- TO:** Santa Barbara County Board of Supervisors
- FROM:** Alex Tuttle, Supervising Planner/Environmental Hearing Officer, Planning and Development
Planner Contact: Andrew Raaf, Santa Barbara County Flood Control District, prepared with assistance from Padre Associates, Inc.
- DATE:** ~~Revised~~ ~~at~~ ~~12/3/20~~
- RE:** Environmental Impact Report (EIR) Addendum for the Randall Road Debris Basin Project, which amends the Environmental Impact Report (SCH #2019029104).
- Location:** The project site is located in Santa Barbara County within the community of Montecito, specifically at the intersection of East Valley Road (State Route 192) and Randall Road (see Figure A-1).

1.0 INTRODUCTION

The Final EIR (State Clearinghouse no. 2019029104) was certified and the Randall Road Debris Basin Project was approved by the Board of Supervisors on August 18, 2020. The project consists of the construction and long-term periodic maintenance of a new debris basin on San Ysidro Creek to capture sediment and debris transported from the watershed upstream of the project site. To date, project construction has not been initiated.

**FIGURE
A-2**

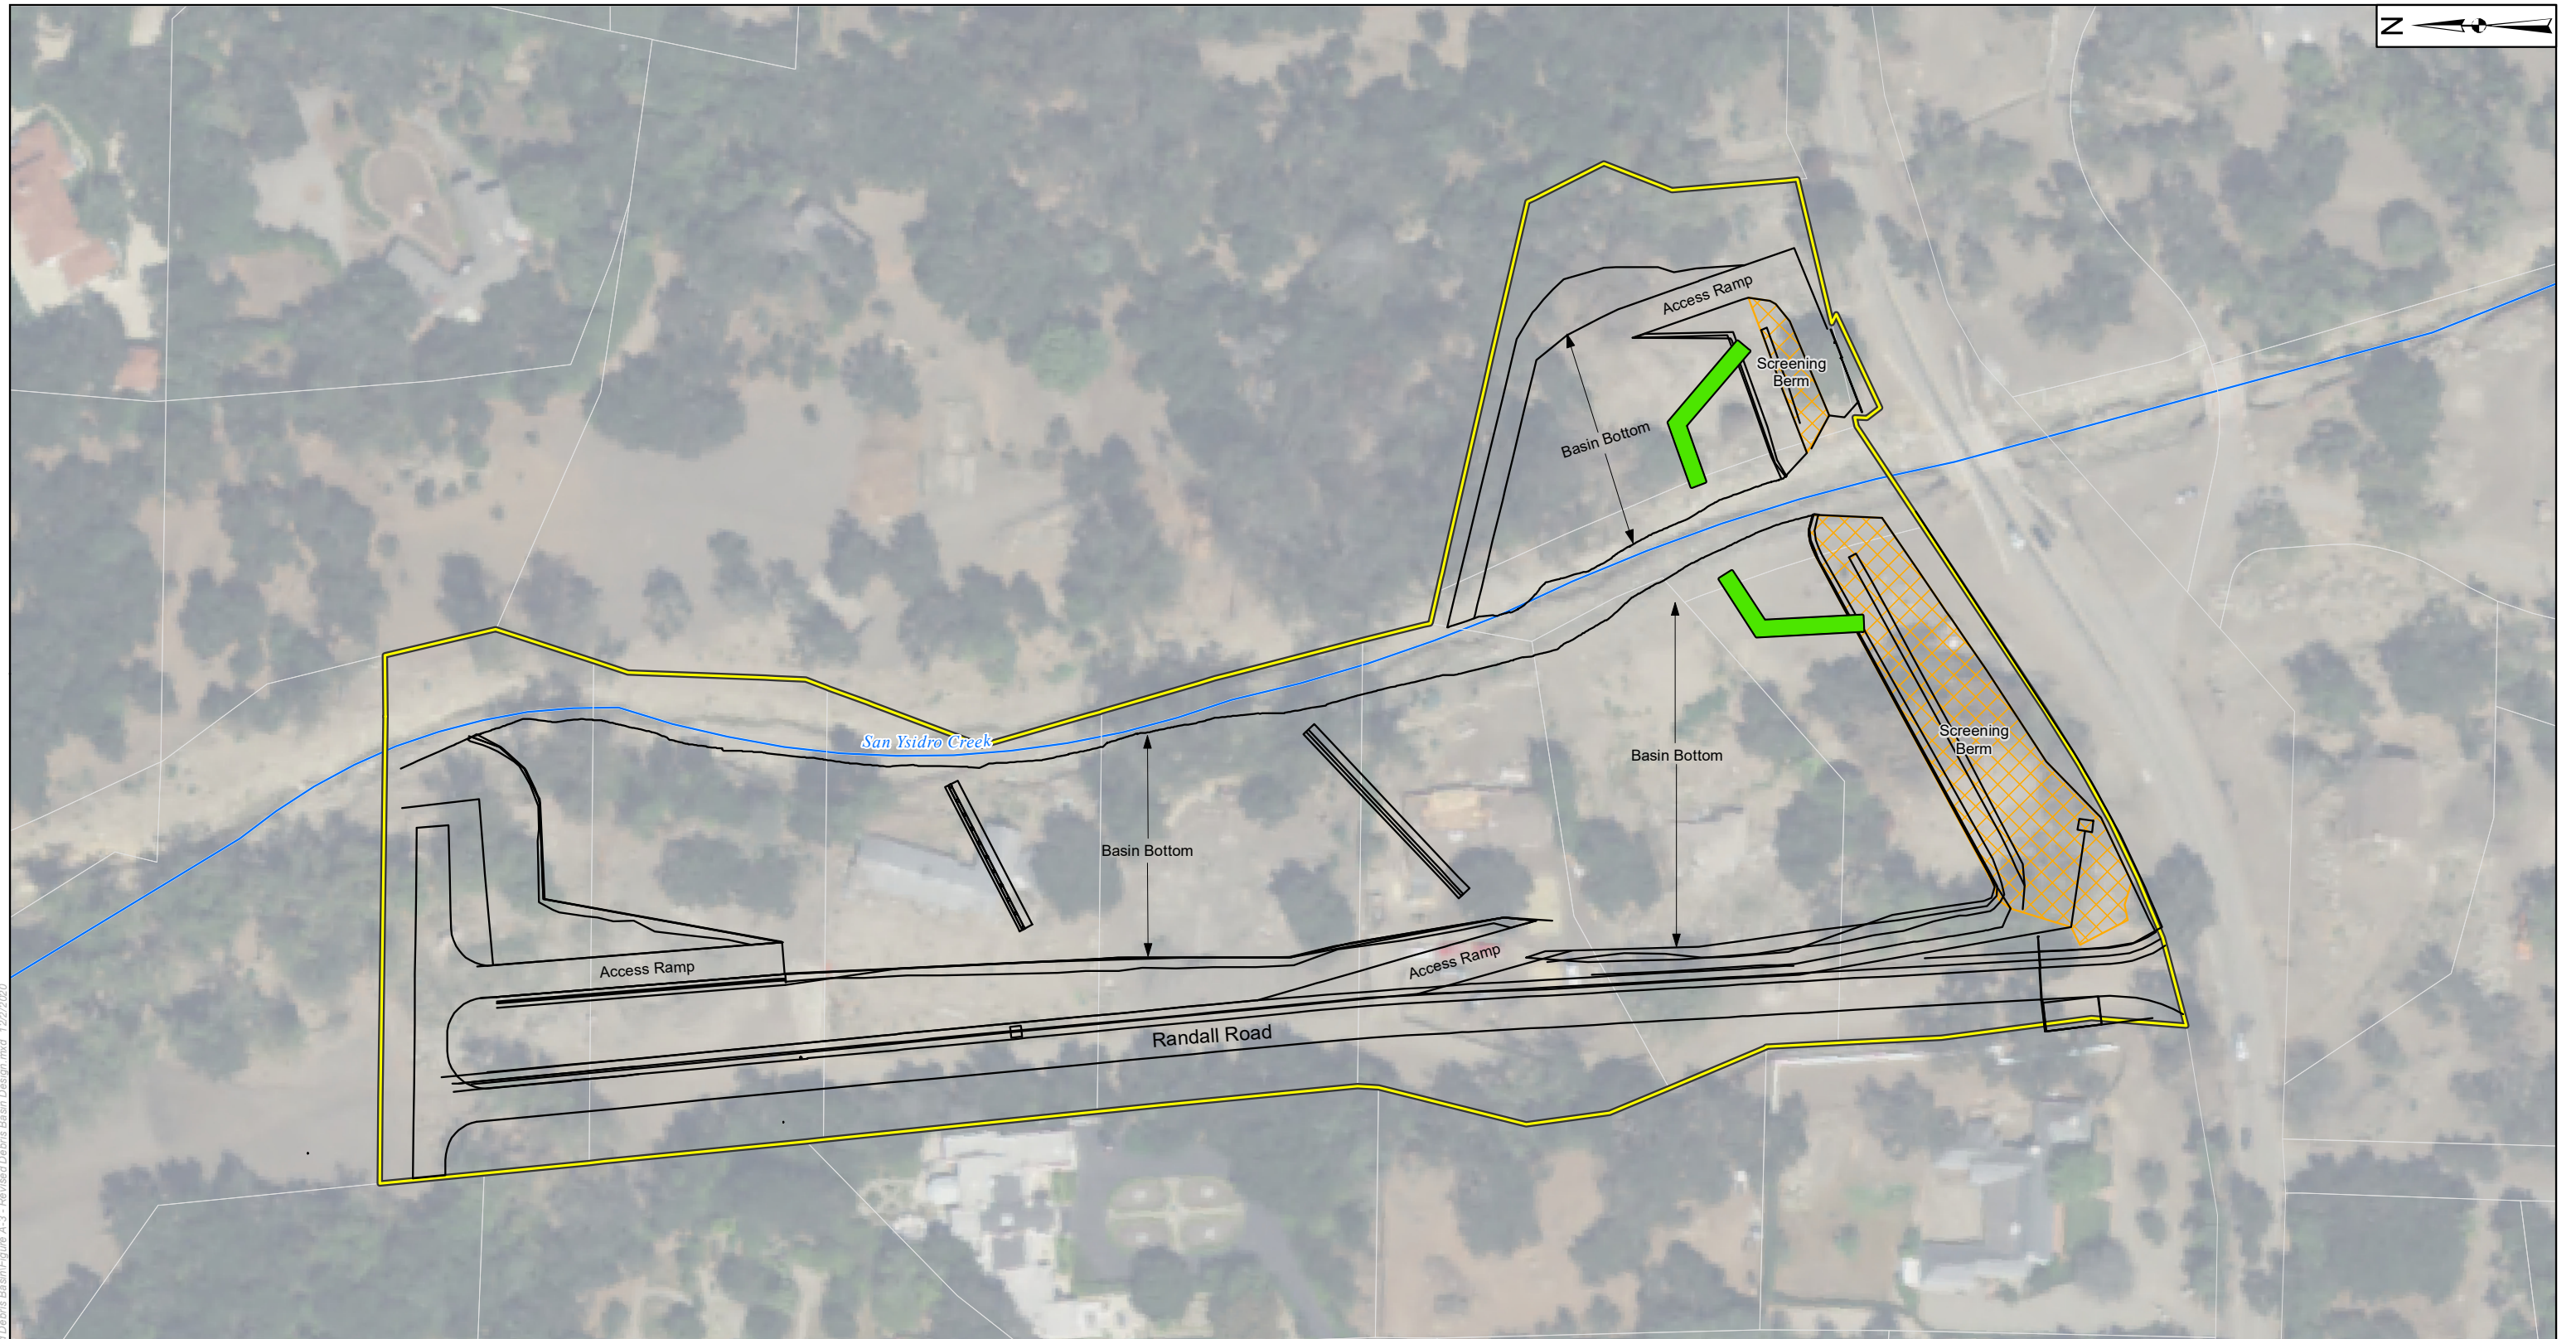
Revised EIR graphics are provided, including the project location map (Figure A-1), revised debris basin design (Figures A-2 and A-3) and revised restoration plan (Figure A-4). Note that Figure A-2 shows the Phase 1 debris basin design, which is only applicable to the phased construction scenario. Both Figures A-2 and A-3 show an earthen berm for screening views of the site from East Valley Road, which represents implementation of Mitigation Measure **MM AES-1**.

The proposed improvements would encompass approximately 8.5 acres in area, including the modified channel, revised debris basin and access areas (see Figures A-2 and A-3). The Phase 1 basin would be approximately 3.2 acres in area, with an additional 2.5 acres added in Phase 2. The bottom surface of the debris basin would be approximately five to 20 feet below existing grade elevations (forming a subgrade excavation).

- Construction activities including excavation and export of earth material would be phased with about 60,000 cubic yards excavated and 58,000 cubic yards exported in Phase 1 (2021). The balance (about 30,000 cubic yards excavated and exported) would occur in Phase 2 (2022). Peak day and average day truck trips would not change.
- Export of earth material would occur in Phase 1 over a 45 to 60 day period, and a 20 to 30 day period in Phase 2.
- Basin construction in Phase 1 would not include APN 007-120-100; however, this parcel may be used for construction staging.
- Basin construction in Phase 1 would not include APN 007-120-054; however, a screening berm would be constructed on this parcel along East Valley Road (see Figure A-2).

**FIGURE
 A-3**

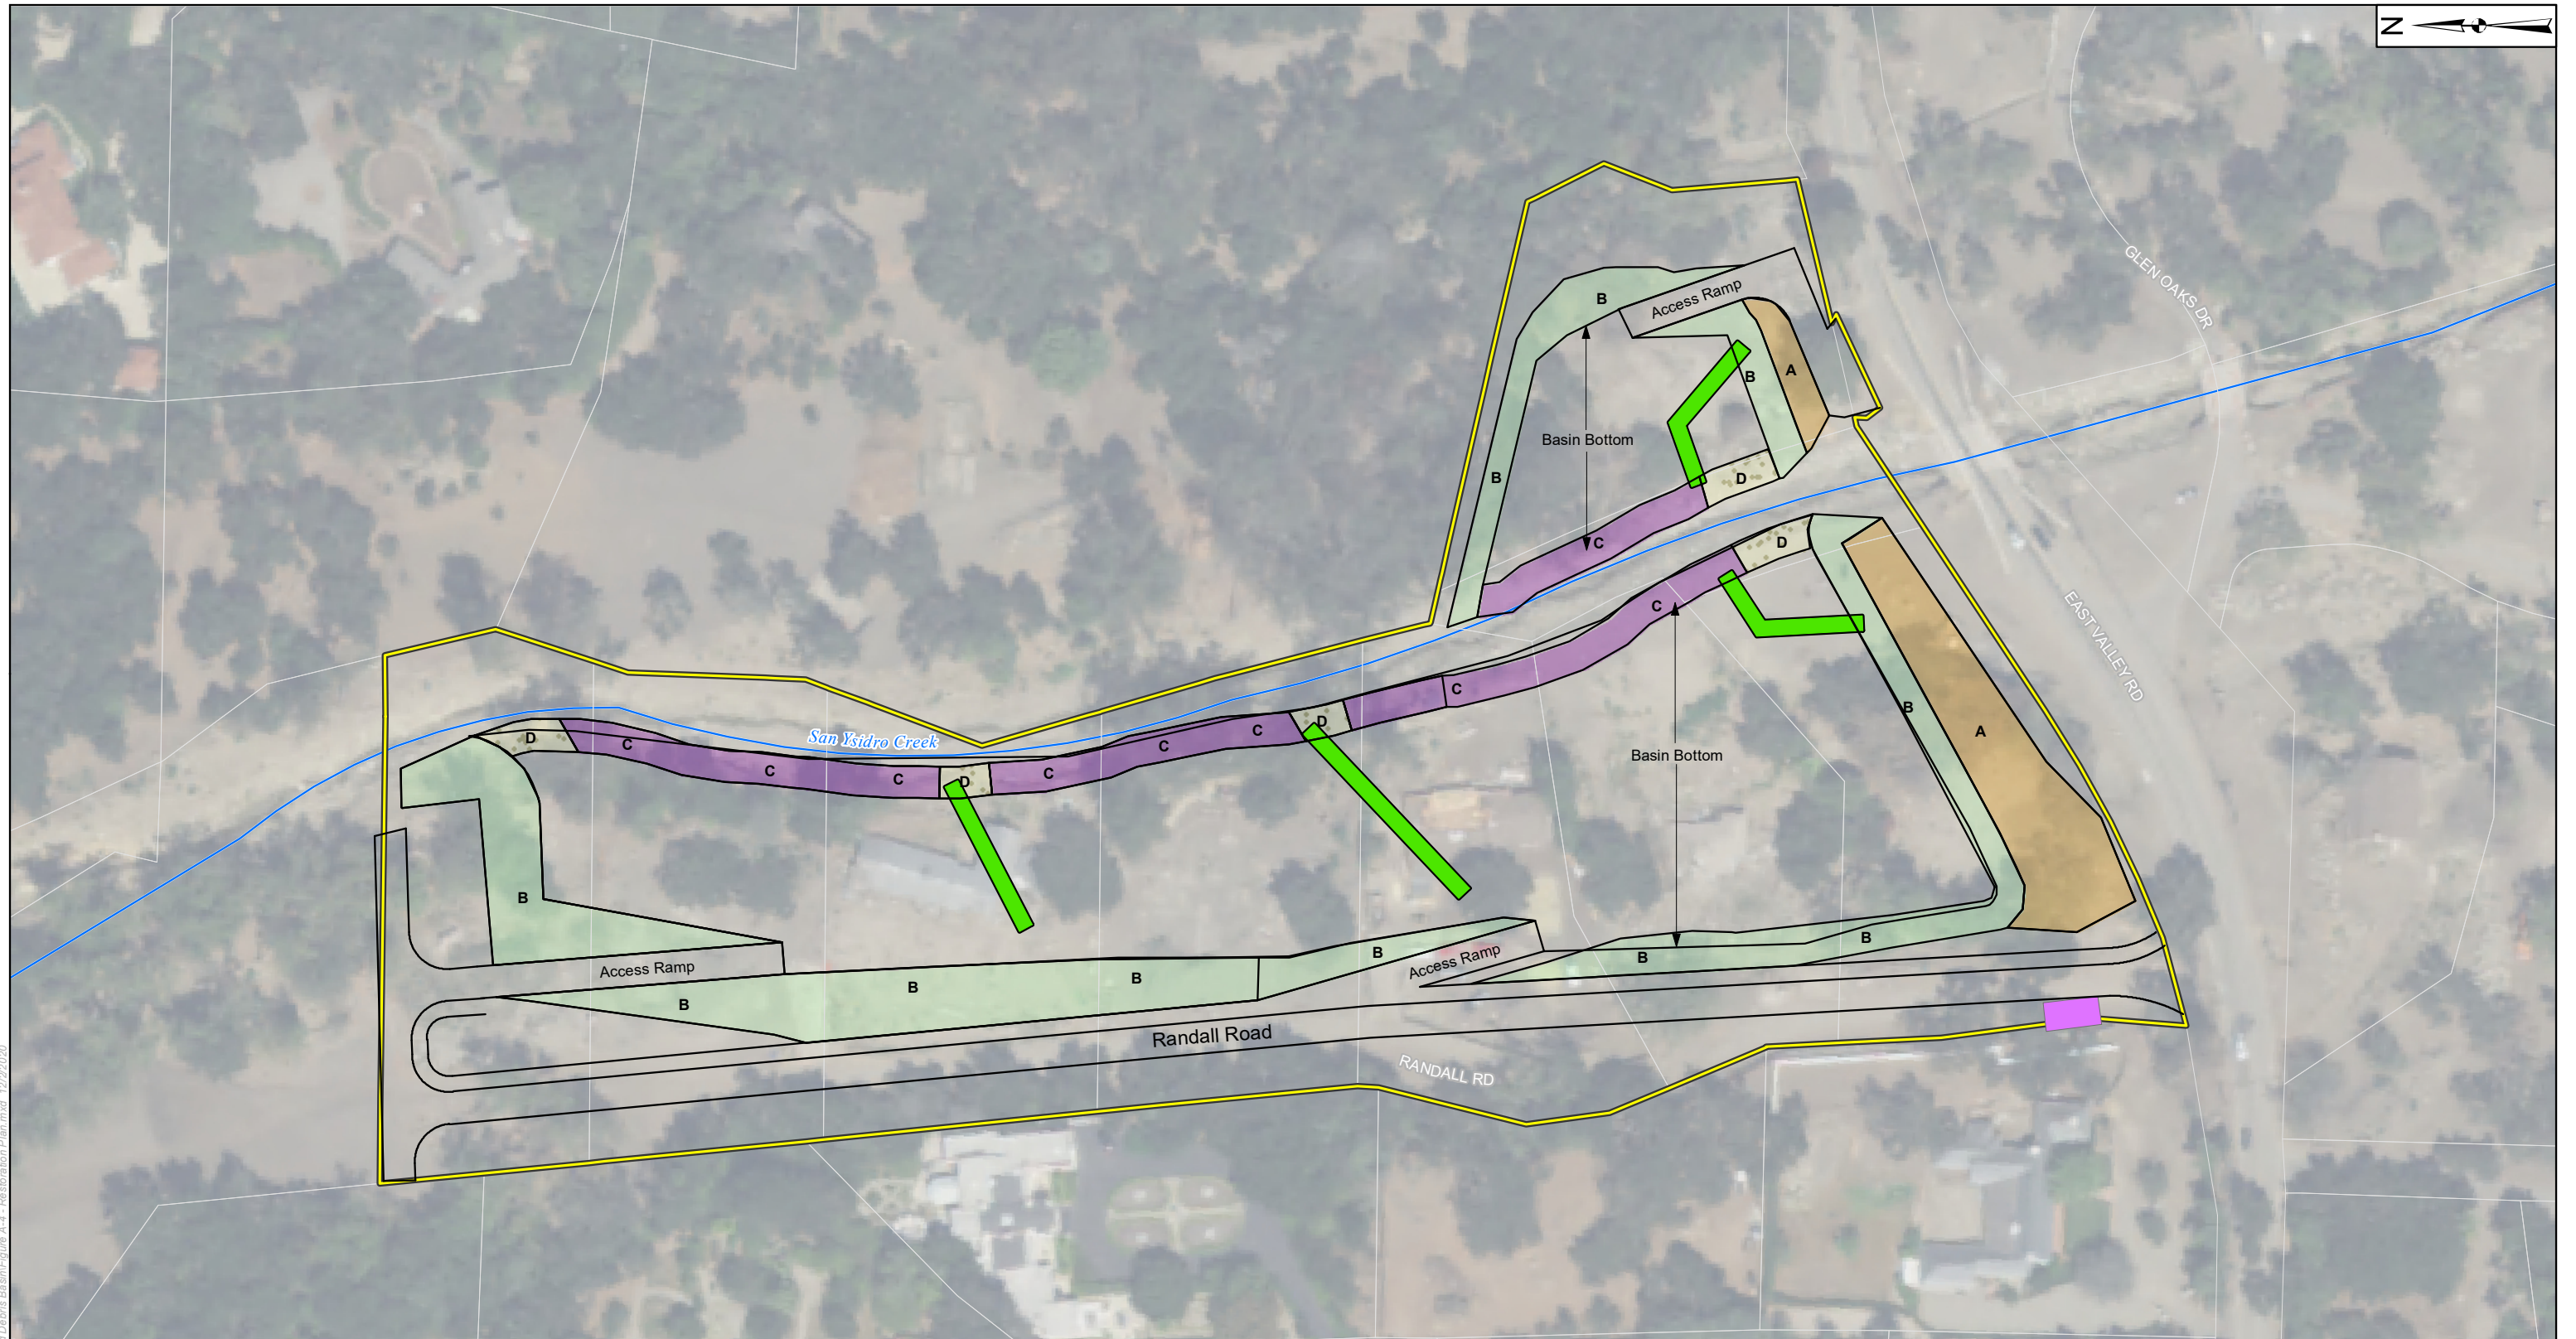
1. The debris basin design has been modified to delete project components on the east bank of San Ysidro Creek (including earthwork or restoration) on APN 007-120-090. However, construction access on this parcel would be required. This results in a reduction in the project site area from approximately 9.2 acres to 8.5 acres, and a reduction in the area of the portion of the debris basin east of San Ysidro Creek. In addition, the amount of excavation and other earthwork on APN 007-120-100 would be slightly reduced.

3. Change 1 listed above would result in a reduction in excavation volumes from about 97,000 cubic yards (per the certified Final EIR) to about 90,000 cubic yards total, with about 60,000 cubic yards in Phase 1. The total volume of earth material to be exported would be about the same as that estimated in the certified Final EIR (87,000 cubic yards).

4. Channel recontouring and sloping of streambanks would be reduced as work on the east bank would be reduced (see Change 1 above). Rock placement within the creek channel would be deleted.

The revised debris basin would include Class VII rock (one-half ton) and Class III rock (25 pound) to be placed on the basin slopes, sloped channel banks and at the base of the debris racks.

The San Ysidro Creek channel and bank recontouring would be reduced. The western bank would be sloped back to form the eastern limits of the debris basin and protected with Class VII rock. The eastern channel bank along northern portion of the basin (to be constructed in Phase 1) would not be graded or modified. The eastern channel bank along southern portion of the basin (to be constructed in Phase 2) would be graded to form a 2:1 slope and protected with Class VII rock. Rock or other earth material would not be placed in the channel bottom.

The proposed improvements would encompass approximately 8.5 acres in area, including the creek channel, revised debris basin and access areas (see Figure A-3). The revised debris basin would be the same as described in Section 4.1.1 (Phases 1 and 2 combined) but constructed in a single year.
